STANDARD DEPARTURE CHART-INSTRUMENT

RJFN / NYUTABARU

SID and TRANSITION

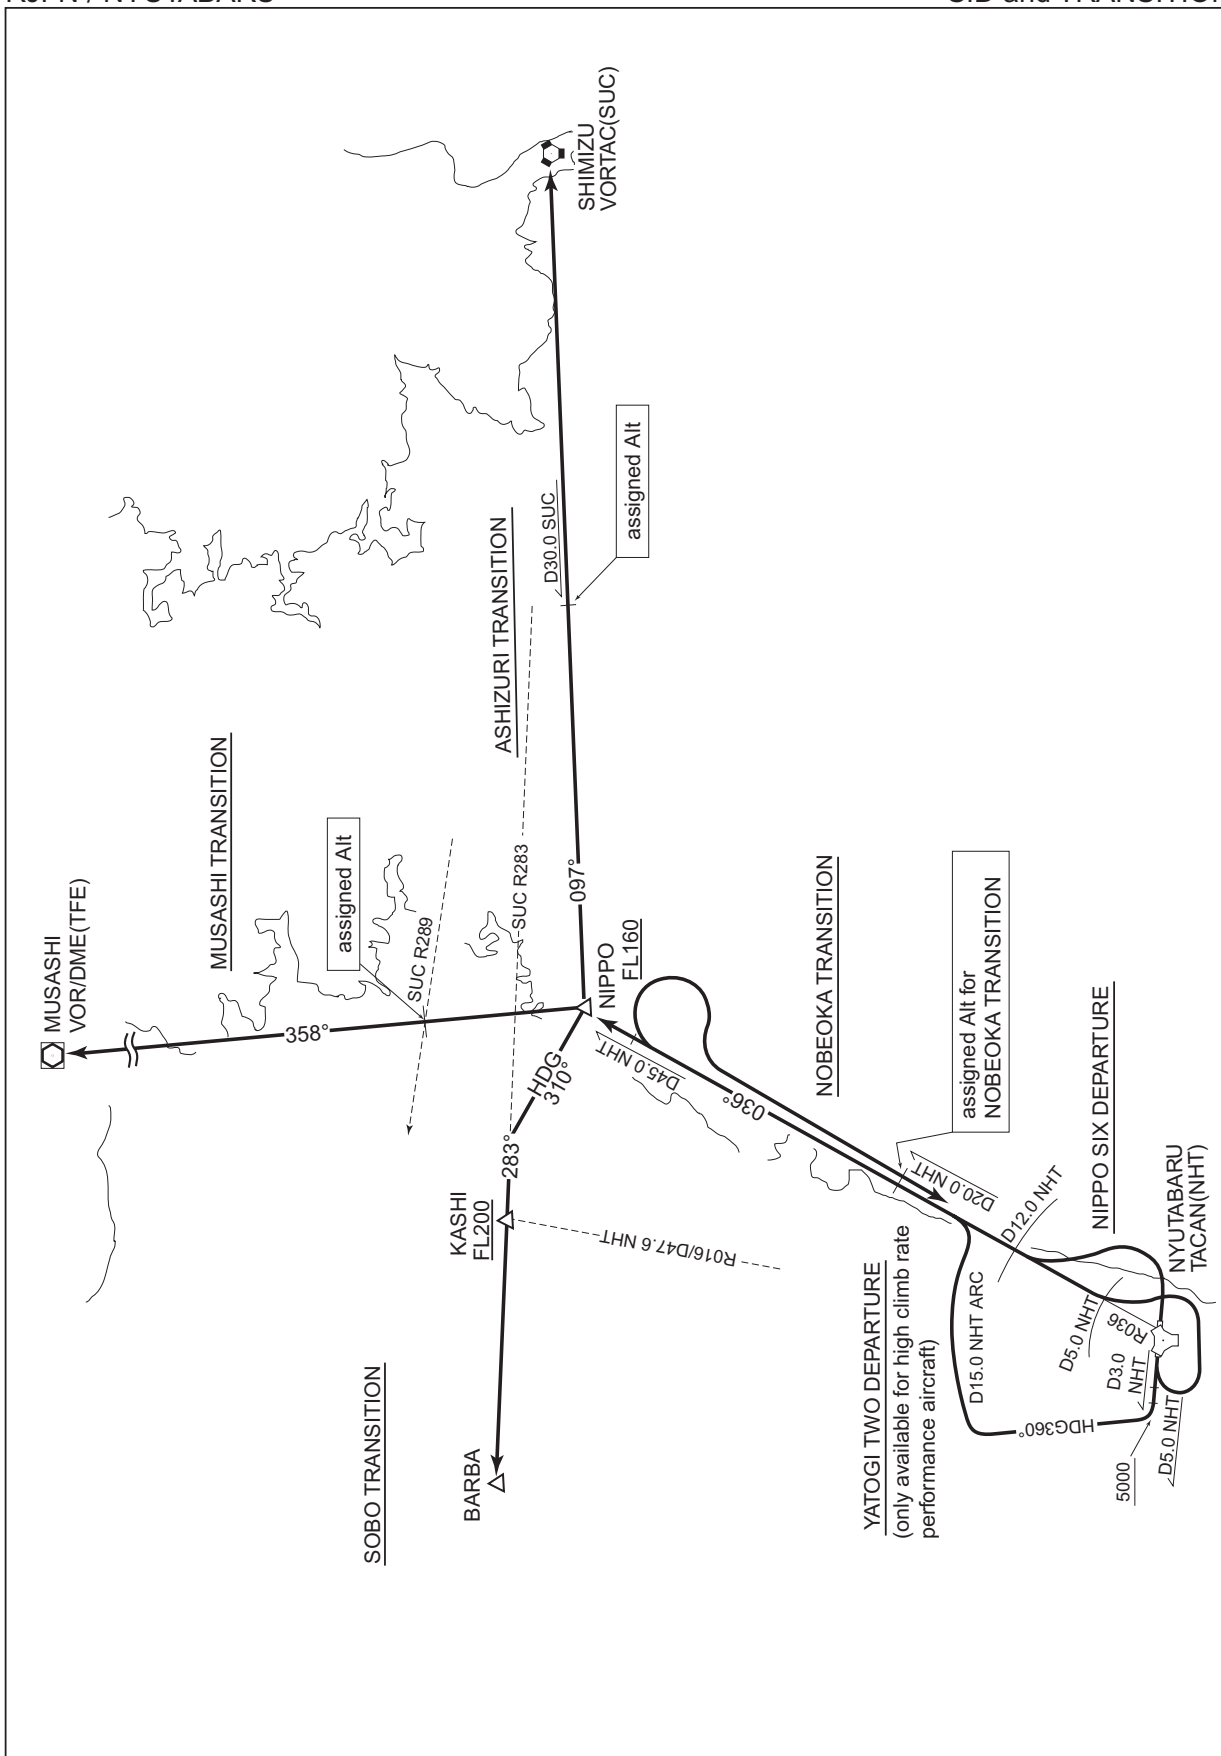
CHANGE : PROC renamed(NIPPO SIX DEPARTURE, YATOJI TWO DEPARTURE). PROC course(NIPPO SIX DEPARTURE, YATOJI TWO DEPARTURE, NOBEOKA TRANSITION).

TENSO THREE DEPARTURE

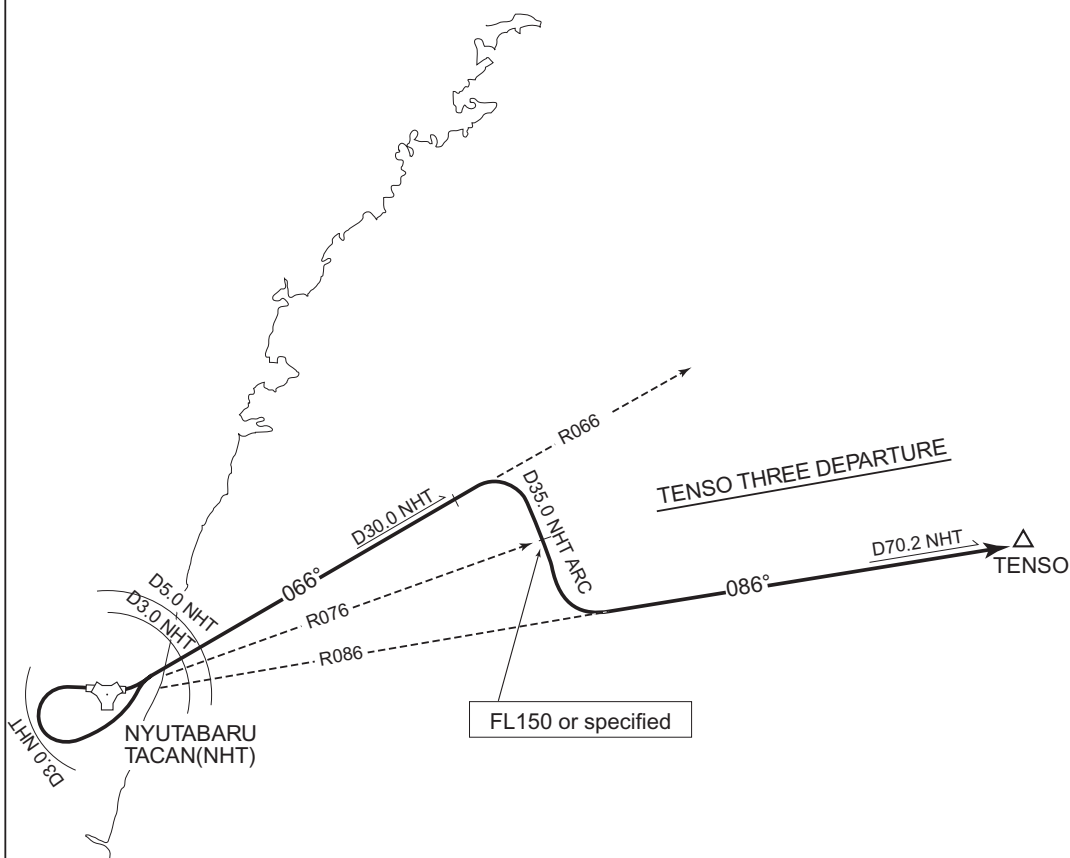
CHANGE : PROC renamed. PROC course.

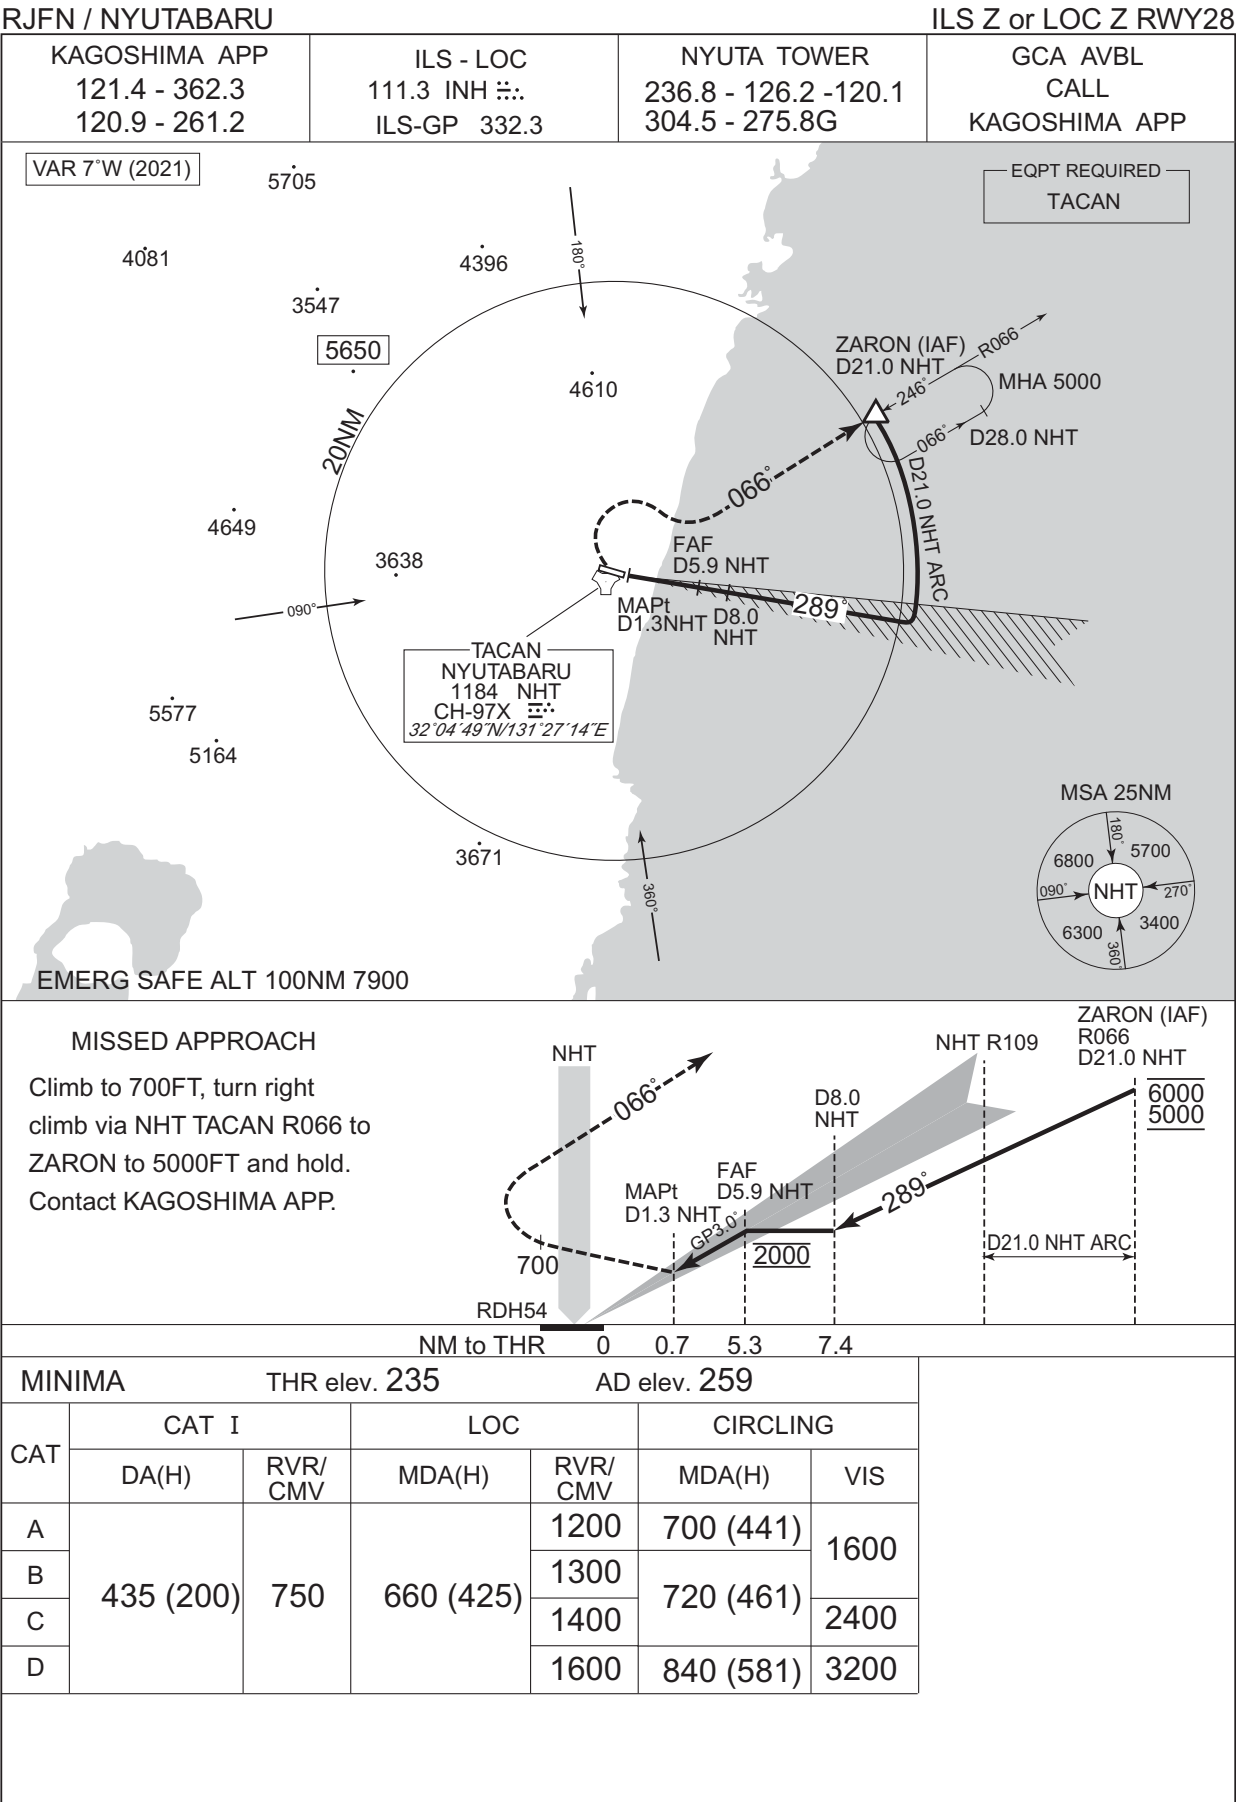
CHANGE : VAR. PROC renamed. EQPT REQUIRED added. PROC course. MISSED APPROACH course. MSA.
NM to THR added. MDA(H) for CIRCLING.

INSTRUMENT APPROACH CHART

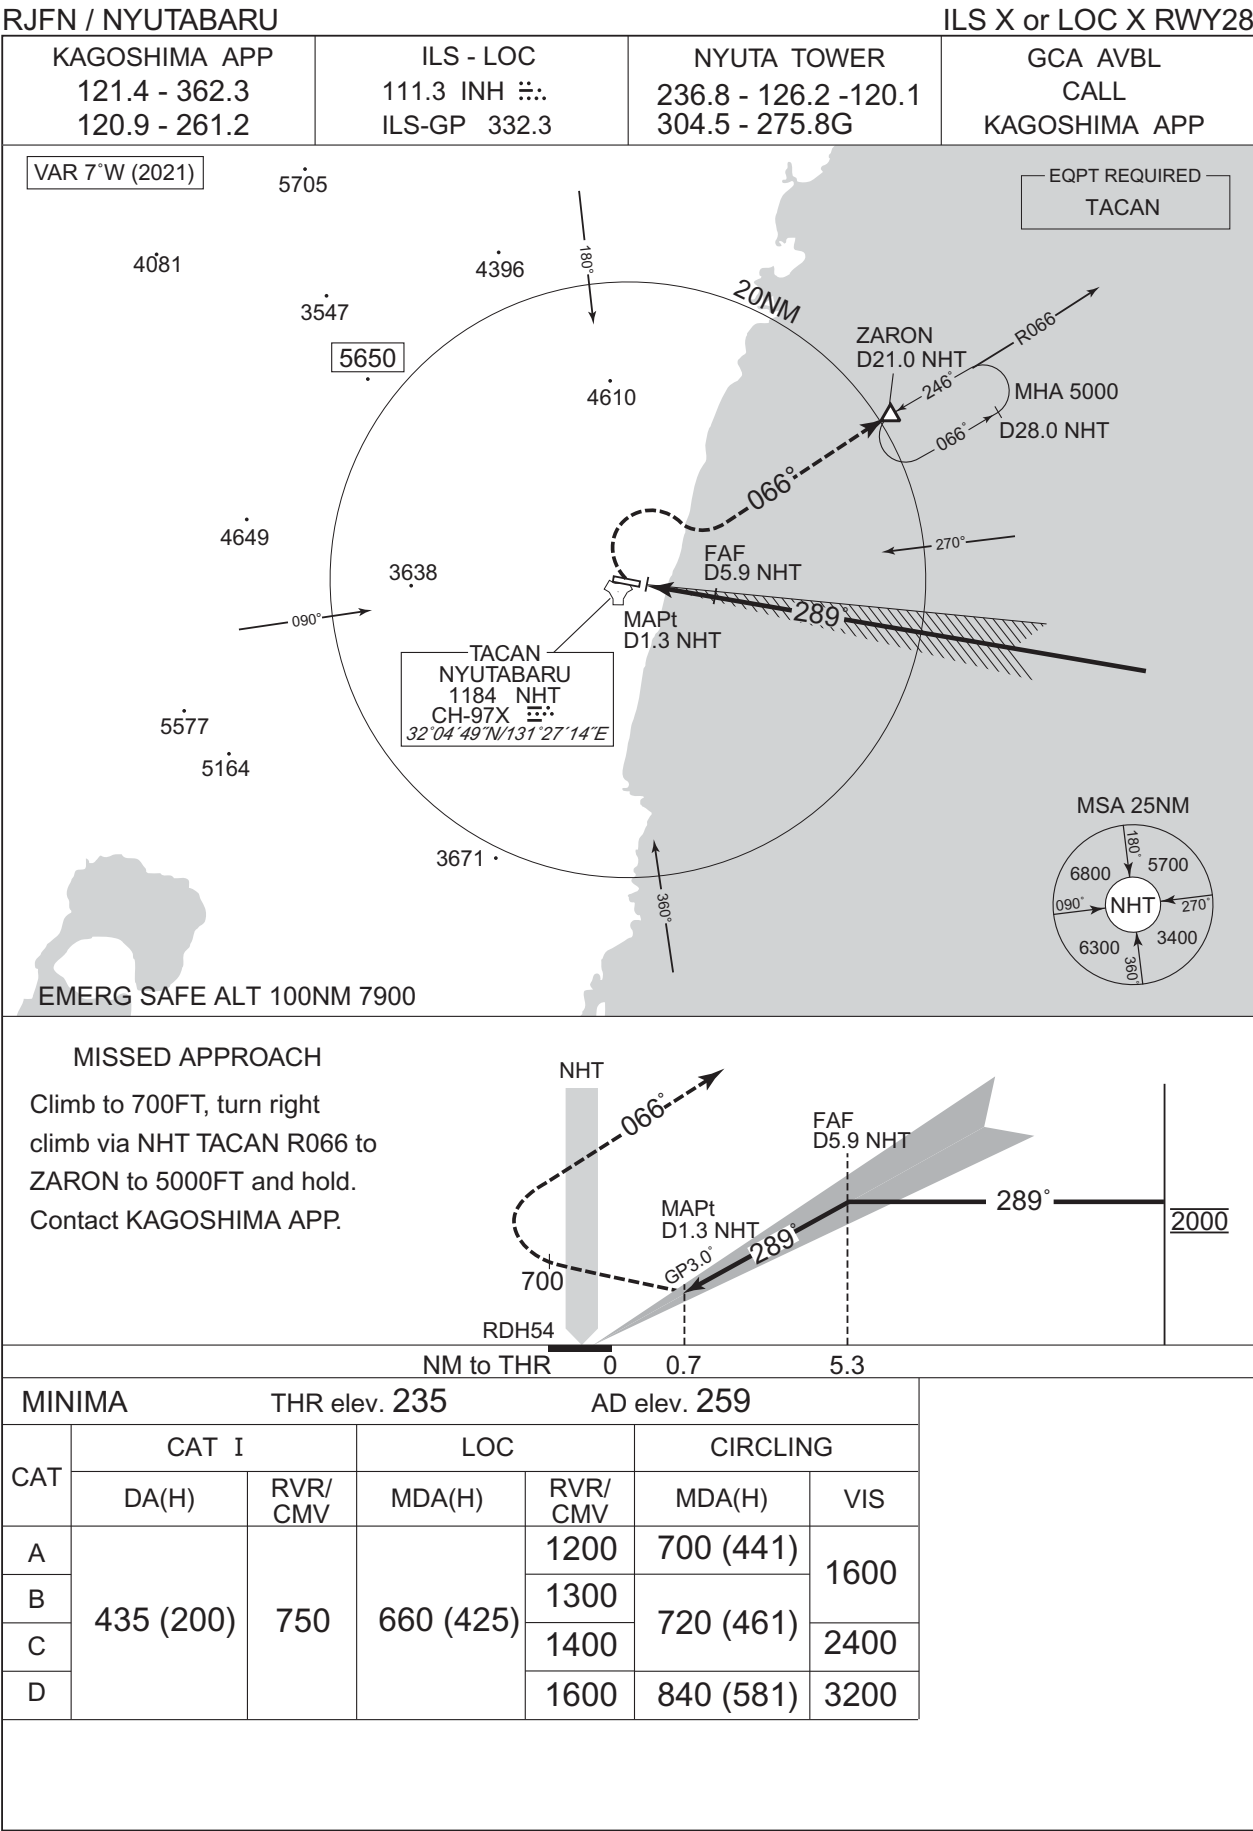
CHANGE : VAR. PROC renamed. EQPT REQUIRED added. PROC course. MISSED APPROACH course. MSA.
NM to THR added. MDA(H) for CIRCLING.
